**COMMUNITY DEVELOPMENT
DEPARTMENT REPORT**

HEARING DATE: 4/16/2026
TO: Planning & Zoning Commission
FROM: Bill Parsons, Planning Supervisor
bparsons@meridiancity.org
Linda Ritter, Associate Planner
lritter@meridiancity.org
208-884-5533
APPLICANT: Laren Bailey, Conger Group
SUBJECT: H-2026-0001
Skybreak Rim MDA, PP, RZ
LOCATION: Near the SEC of S. Eagle Road and E. Lake Hazel Road, located in the NE ¼ of the NE ¼ of Section 4 Township 2N, Range 1E Parcel # S1404212755

Note: See City/Agency Comments and Conditions Section and public record for all department/agency comments received. Skybreak Rim Subdivision MDA, PP, RZ H-2026-0001 (copy this link into a separate browser).

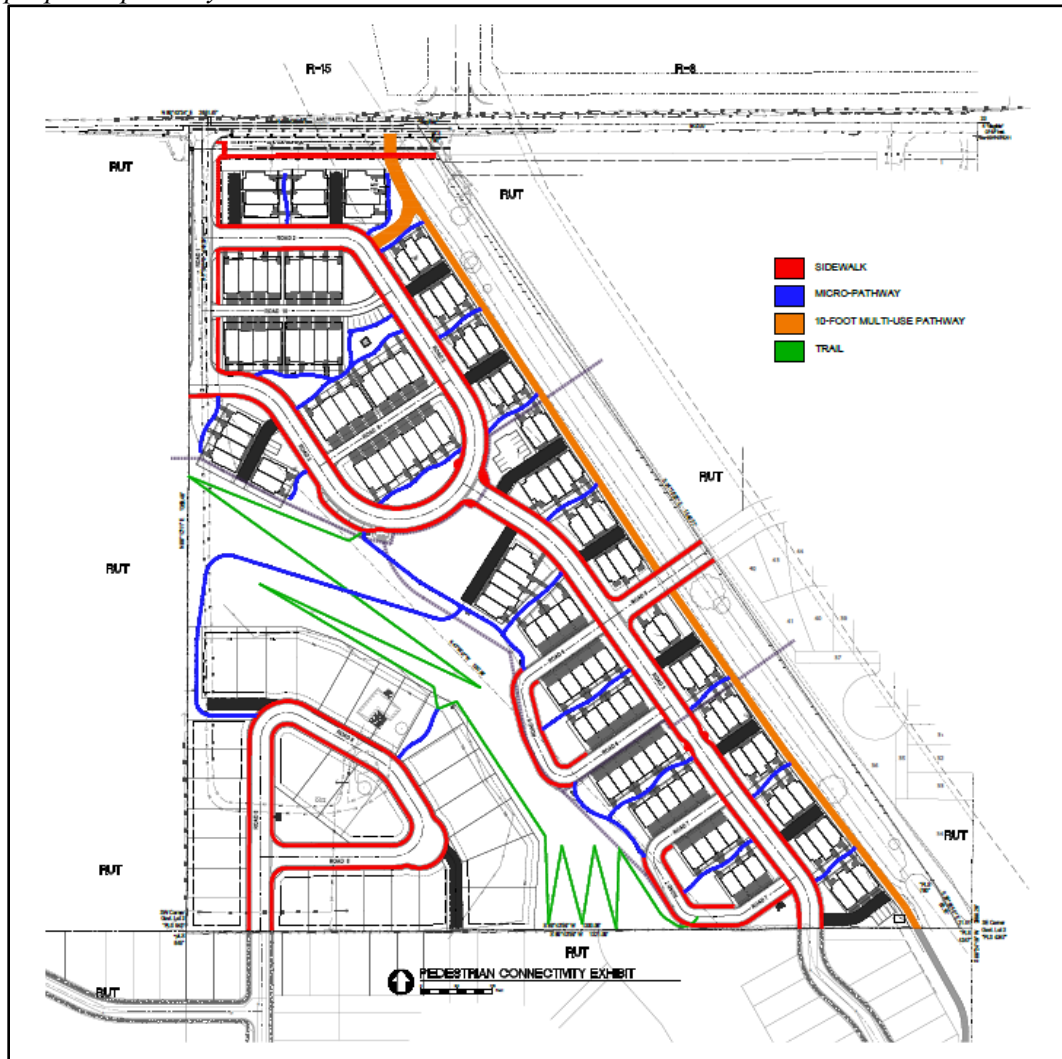
The applicant is proposing a pathway on the north side of the property that connects to a foothill trail descending the slope. This trail will be designed as a natural switchback along the hillside, with disturbed areas reseeded and maintained in a natural condition. In addition, a separate pathway is proposed within the open space area along the private road. This pathway is standalone and does not directly connect to existing sidewalks or other pathway systems.

The applicant needs to update their pedestrian circulation exhibit to show how they plan to connect the proposed pathway below the slope to Pura Vita Subdivision.

- IV.
1. **Fifteen days prior to the City Council public hearing, the applicant shall submit the following items to the city for review:**
 - **Submit a revised pedestrian exhibit showing how the pathway from Skybreak Rim connects to the pathways within the adjacent subdivisions.**

Pedestrian Connectivity Exhibit

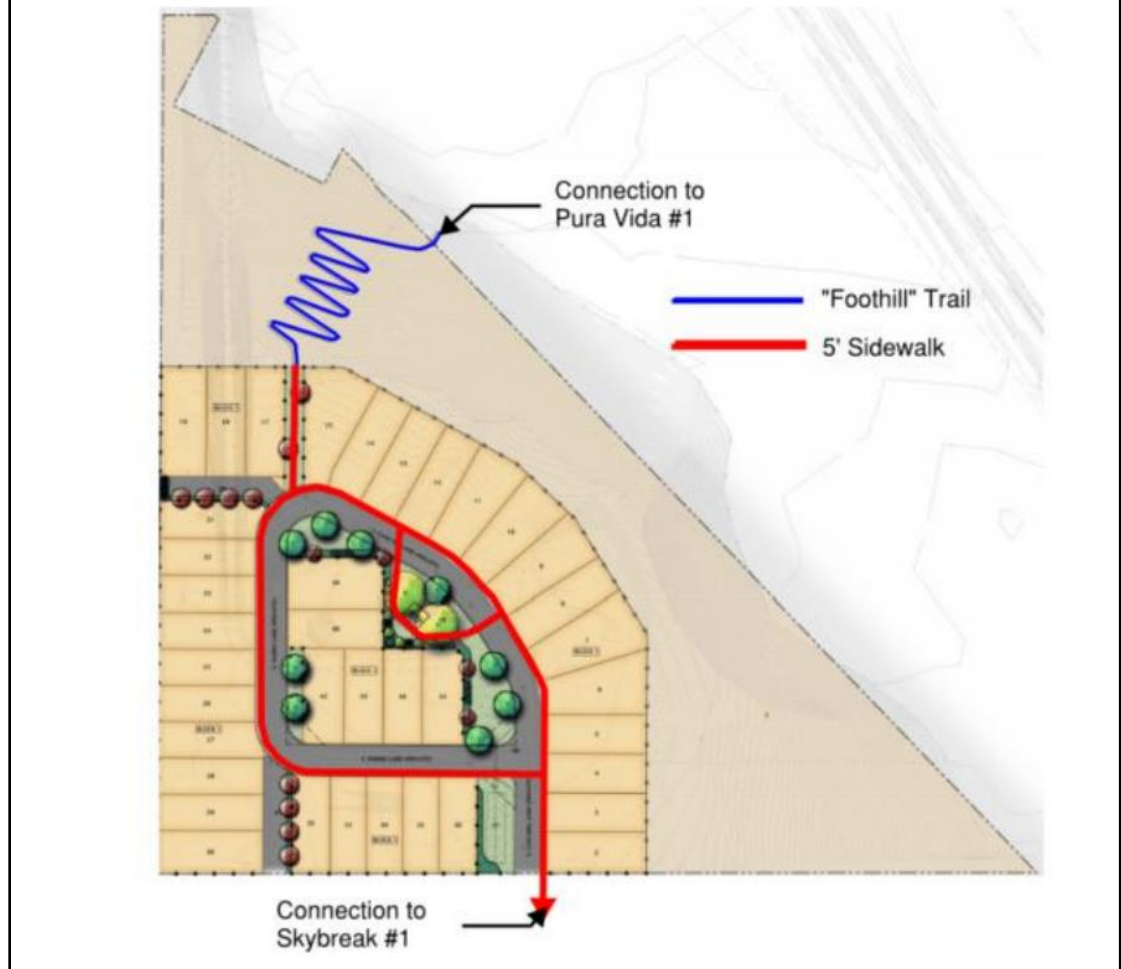
The previous approval provided sidewalks on both sides of the public street connecting to the proposed pathway network as seen in the exhibit below.

The applicant is proposing a private street with a 5-foot sidewalk on the east side which does not meet the requirements of UDC 11-3F-4.C.2.b. The applicant is requesting a waiver to design the same street section and sidewalk configuration approved with the original Skybreak Subdivision (see exhibit below).

As the private street section of the UDC was changed in 2025, the Planning Commission and City Council should carefully consider whether the proposed request meets the intent of the current UDC for sidewalks associated with private streets.

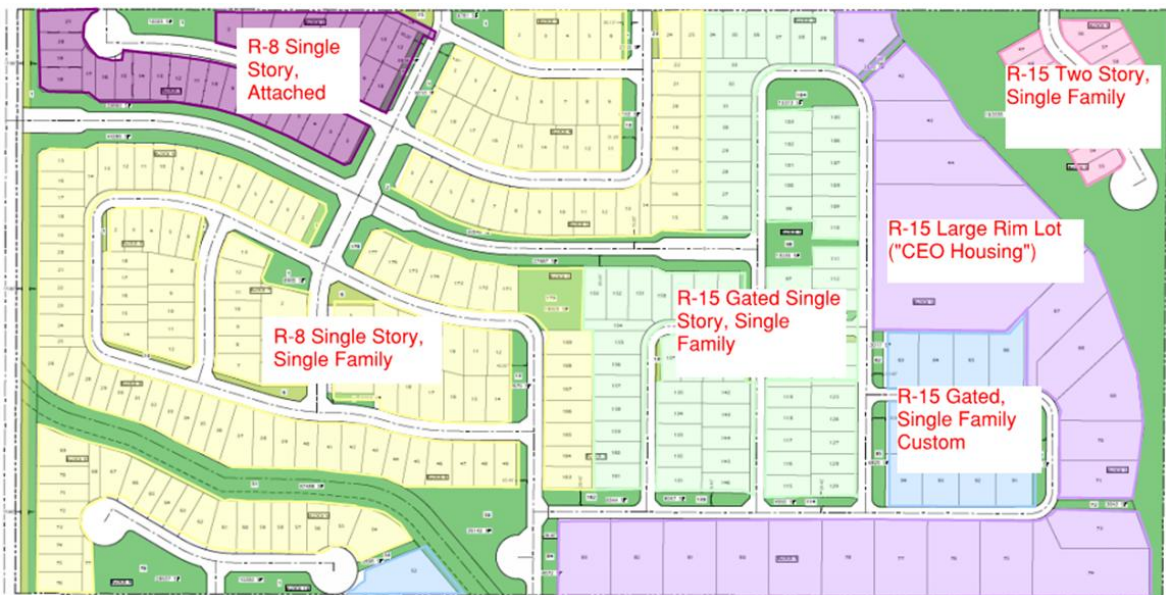
The applicant is required to comply with the private street requirements outlined UDC 11-3. To serve the 38-lot development the applicant is proposing private streets. In doing so, they are proposing to utilize the existing private street network within the Skybreak development. While the proposed subdivision does not include additional gates, the development will connect to and rely on the existing private streets and gated entrances that currently serve the Skybreak community.

The City Council previously approved the Skybreak development with 106 homes served by private streets and two (2) gated accesses. The current proposal would add an additional 38 homes to the private street network.

Pursuant to UDC 11-3F-4, gated residential developments served by private streets shall have no more than one hundred (100) dwelling units, unless a greater number of units is approved through a planned unit development (PUD). The code in effect at the time required

one gated entry for every fifty (50) dwelling units. Given that the previously approved development already exceeded the 100-unit threshold and the applicant is proposing to add an additional 38 homes to the existing private street network, the Planning Commission and City Council should carefully consider whether expanding the number of homes served by this private street system remains appropriate and consistent with the intent of the Meridian City Code.

Additionally, in order to facilitate the proposed connection to the existing private street network, the applicant is required to modify the existing Skybreak Subdivision plat. Specifically, one of the buildable lots within Skybreak Subdivision (Lot 13, Block 1) must be converted to a common lot to accommodate the connection and circulation associated with the private street system. As a result, the applicant will be required to submit a final plat modification for Skybreak Subdivision and a concurrent private street application to allow the proposed connectivity. These applications must be reviewed and approved by the City prior to submittal of the final plat for the proposed subdivision.

2. The applicant shall submit a final plat modification for Skybreak Subdivision and a concurrent private street application to allow the proposed private street access. These applications shall be reviewed and approved by the City prior to submittal of the final plat for the proposed subdivision.
